Re: Love's Sunport Station

Conceptual Traffic Circulation Layout for DFT Approval

Engineer's Stamp 12-06-23 (M14-D038A)

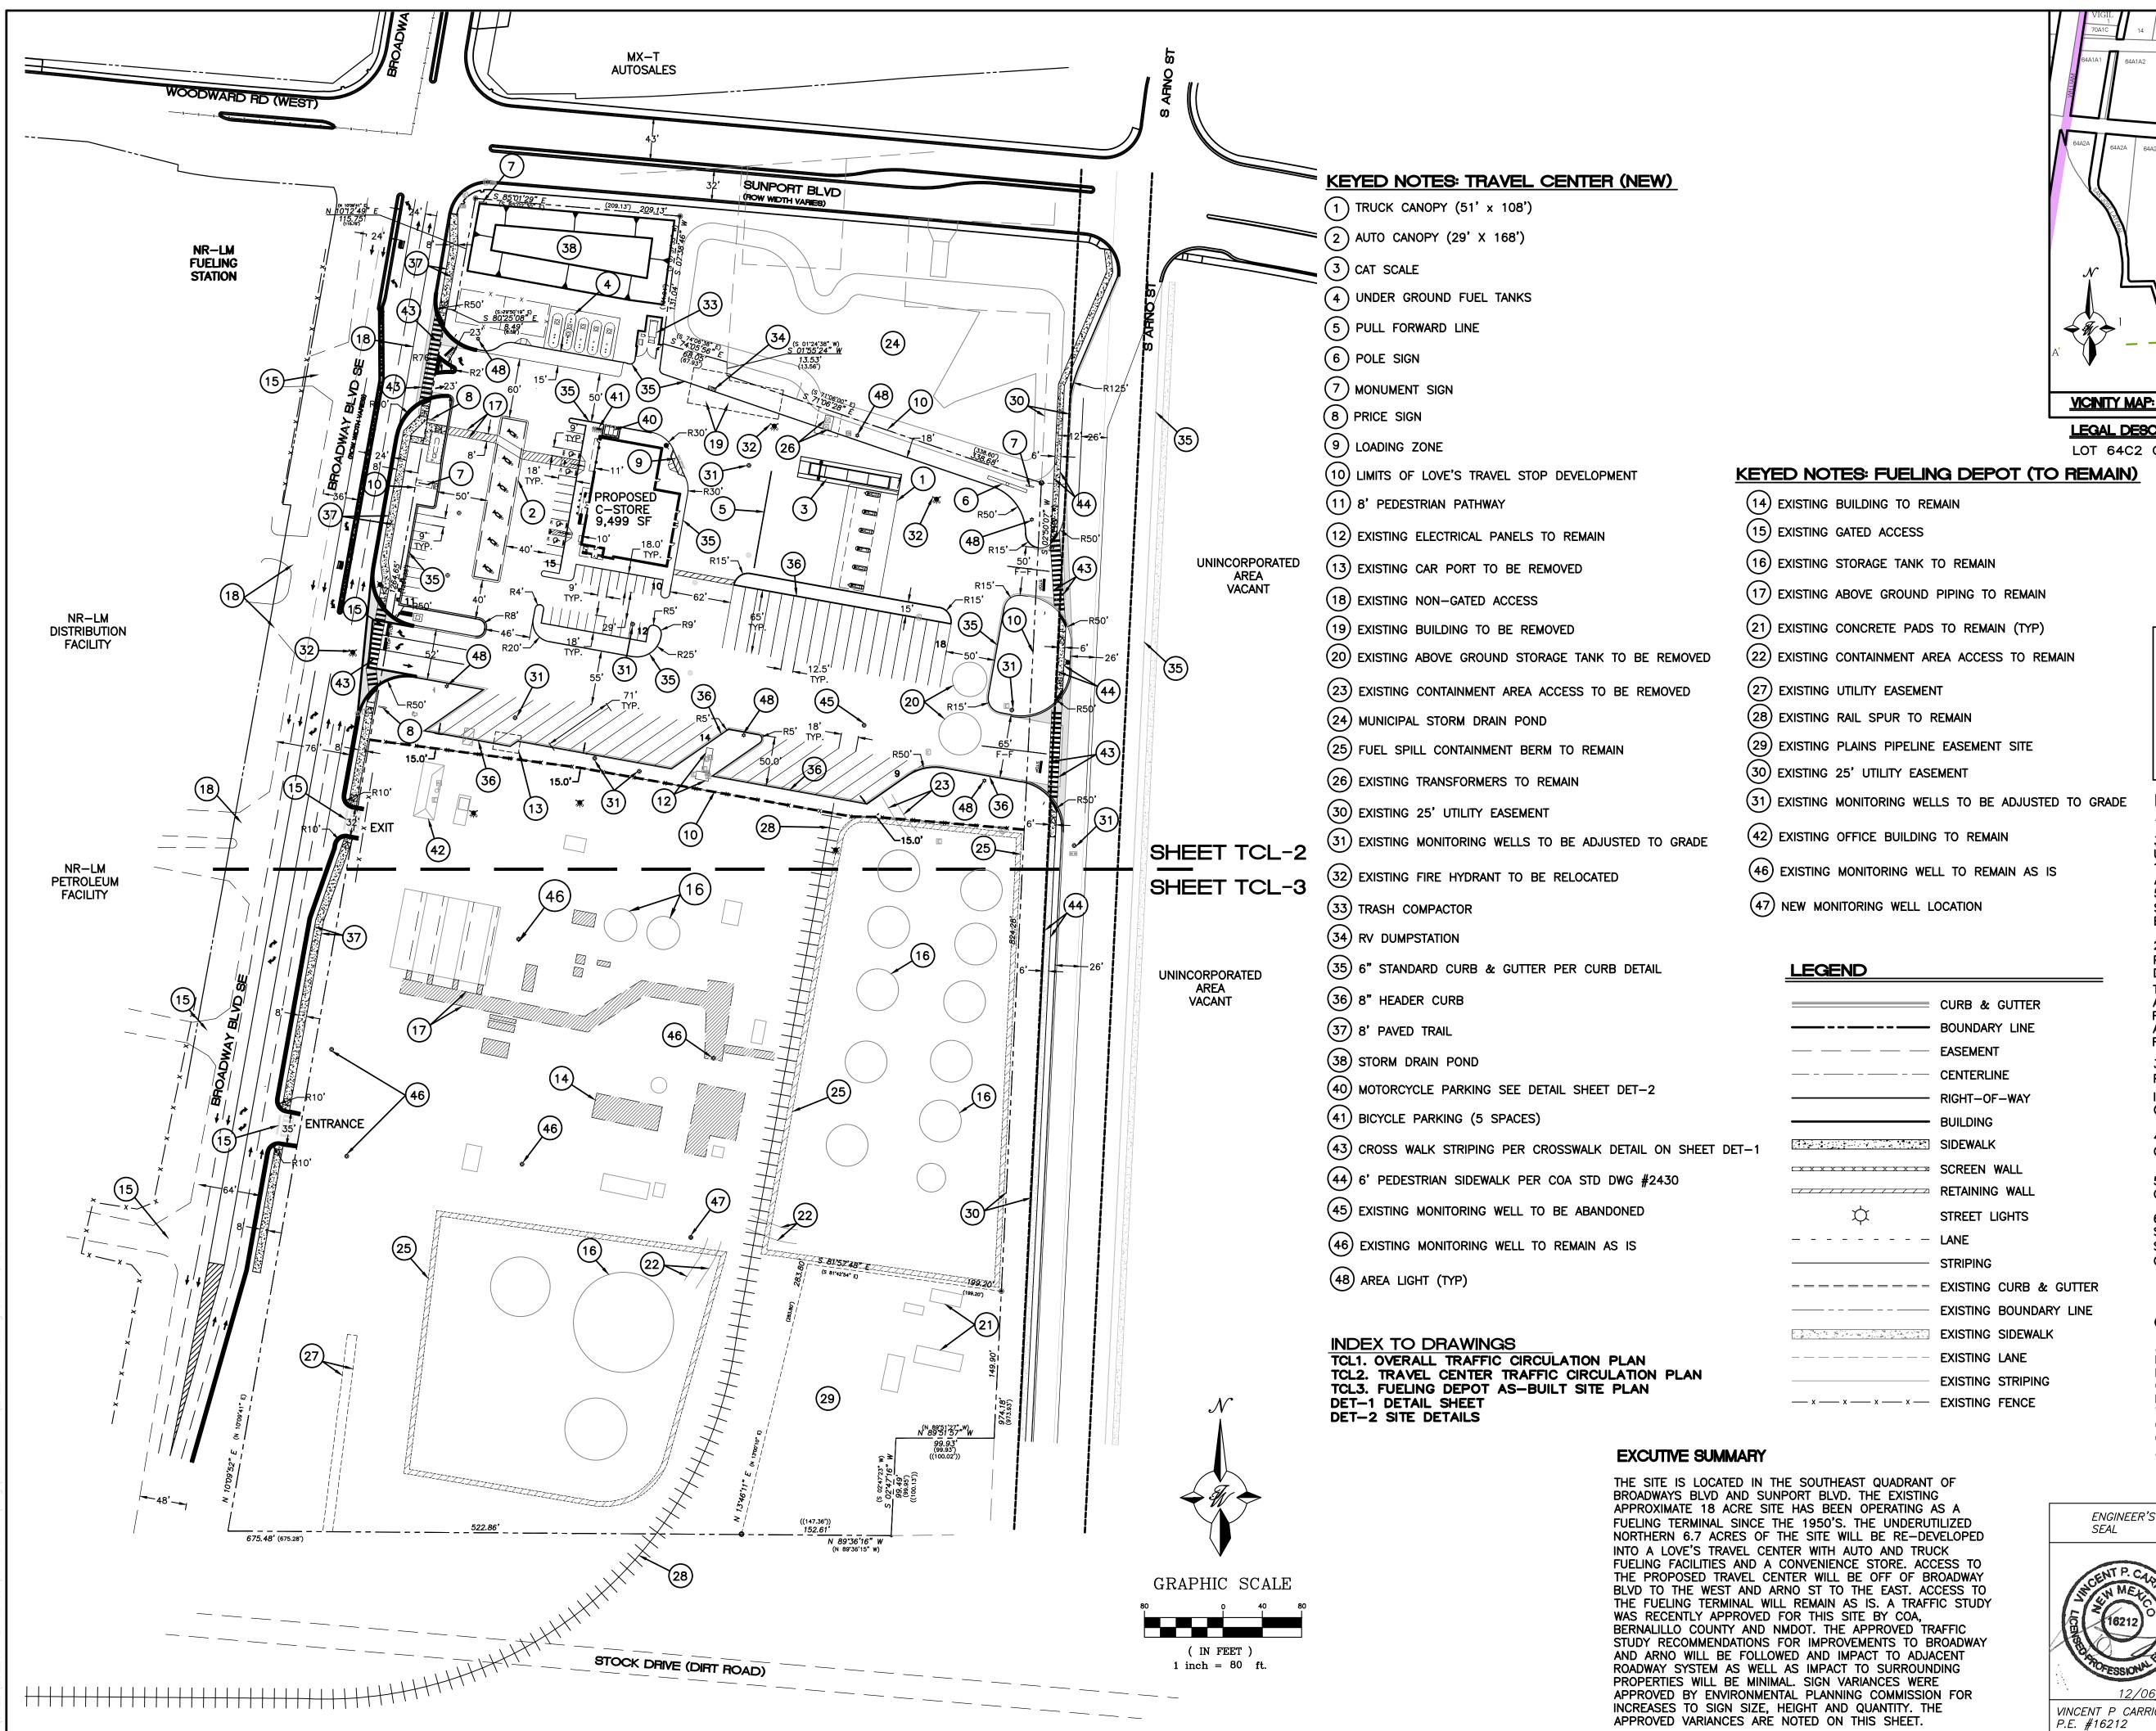
The conceptual TCL submittal received 11-09-2023 is approved for DHO and/or DFT submittal. When submitting this project through the building permit process, a full Traffic Circulation Layout will need to be submitted and approved prior to building permit. When you submit TCL for building permit approval, please provide the following: 8 bicycle parking spaces, and show the clear intersection sight distance at the south east site access.
